SUBJECT : HYUNDAI IT CORP.
FCC ID: PJIL17A00000

Transmitted herewith, on behalf of HYUNDAI IT CORP. is an application for a Class II Permissive Change Certification of the following LCD MOITOR

FCC ID : PJIL17A00000
TYPE : L17A00000

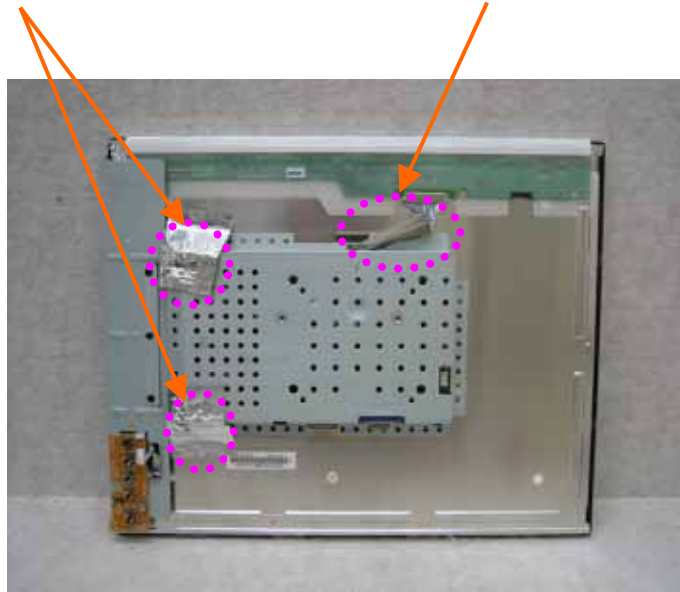
1. Attach the Copper Tape in the Board and Attach EMI Tape in the Board

2. Attach the Gasket in the Board
